AMENDMENT OF SOLICITATION/MODIFICATION OF CONTRACT			1. CONTRACT ID CODE J	PAGE OF PAGES 1   20
2. AMENDMENT/MODIFICATION NO. 0002	3. EFFECTIVE DATE 24-Jan-2006	4. REQUISITION/PURCHASE REQ. NO.		5. PROJECT NO.(If applicable)

14. DESCRIPTION OF AMENDMENT/MODIFICATION (Organized by UCF section headings, including solicitation/contract subject matter where feasible.) The above numbered solicitation for New Orleans To Venice Hurricane Protection Project, Buras Levee District, West Bank River Levee, Emergency Levee Repairs, Contract P17 - B/L Sta. 906+00 to B/L Sta. 1003+00, Plaquemines Parish, LA, is amended as shown on the attached pages.  PROPOSAL DUE DATE: THE PROPOSAL DUE DATE IS CHANGED TO 30 JANUARY 2006, 4:00 PM LOCAL TIME, NEW ORLEANS, LA.				
Except as provided herein, all terms and conditions of the document referenced in Item 9A or 10A, as heretofore changed, remains unchanged and in full force and effect.				
15A. NAME AND TITLE OF SIGNER (Type or print)		16A. NAME AND TITLE OF CONTRACTING OFFICER (Type or print)		
		TEL: _____ EMAIL: _____		
15B. CONTRACTOR/OFFEROR  (Signature of person authorized to sign)	15C. DATE SIGNED	16B. UNITED STATES OF AMERICA  BY _____ (Signatur

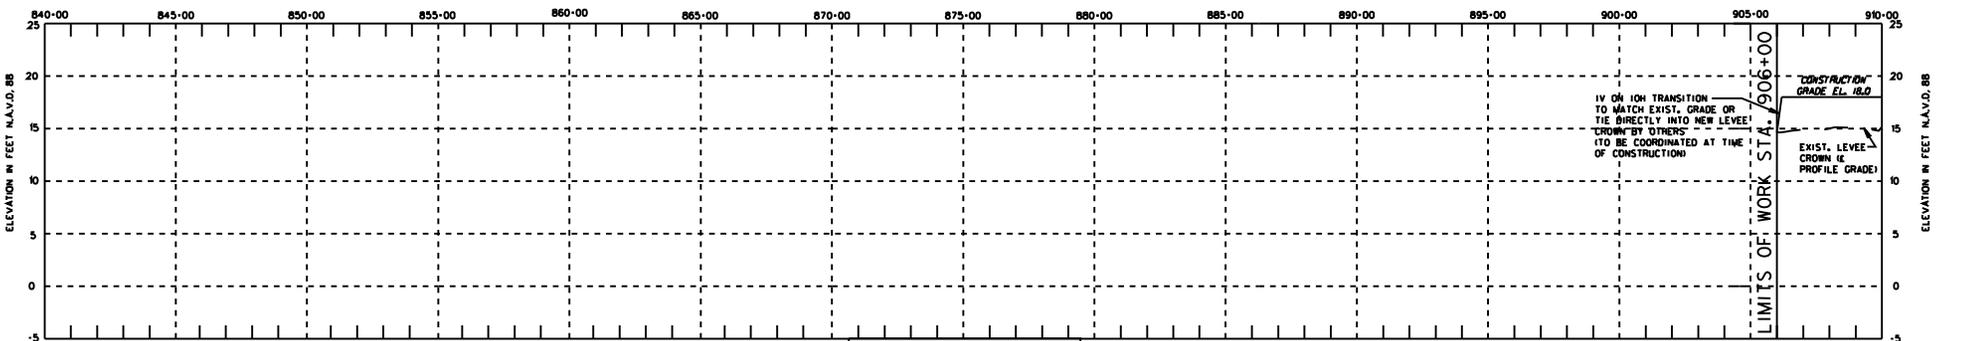
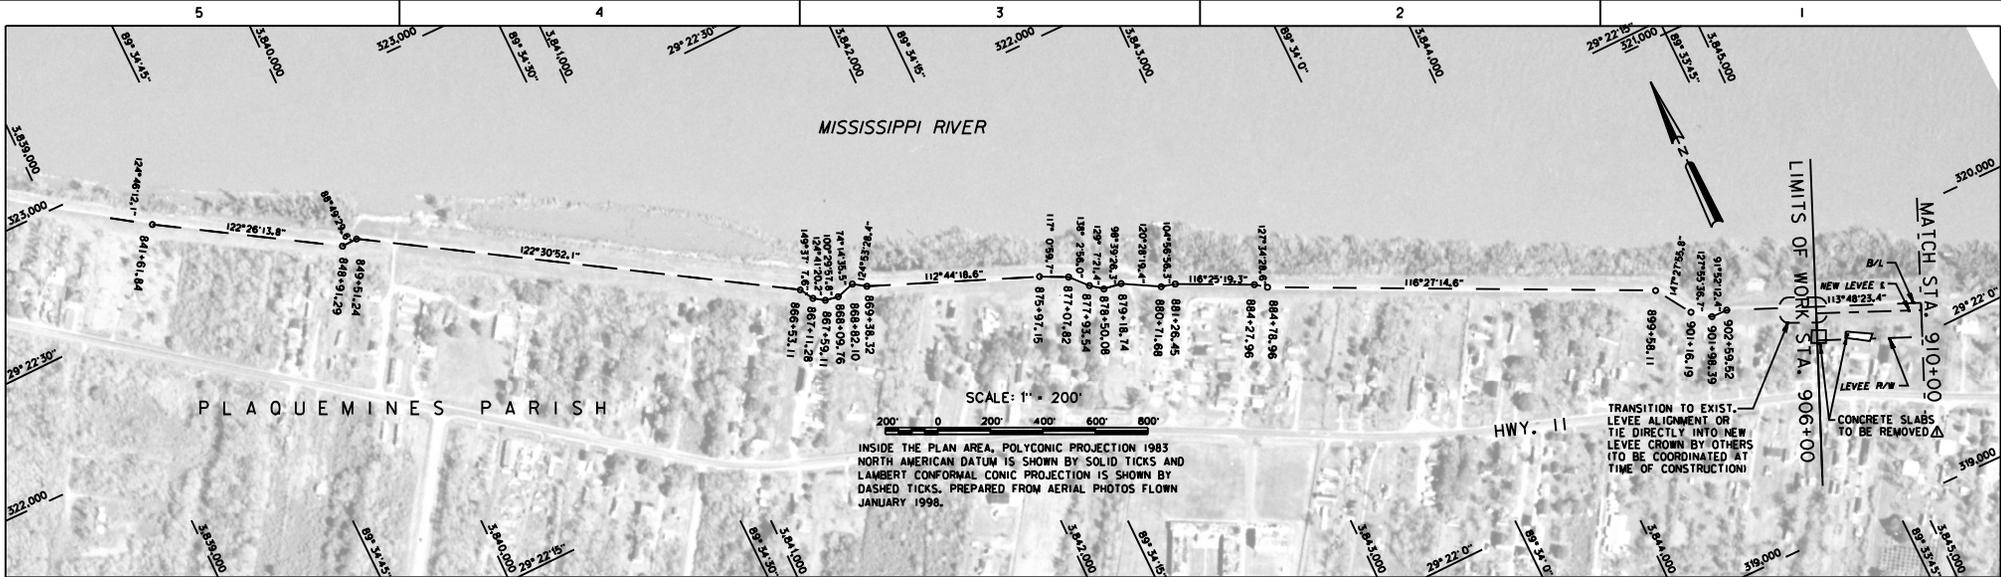
SYMBOL	DESCRIPTION	DATE	APPROVED
▲	ADDED CONCRETE SLAB LOCATIONS.	1/18/06	E.J.P.
REVISIONS
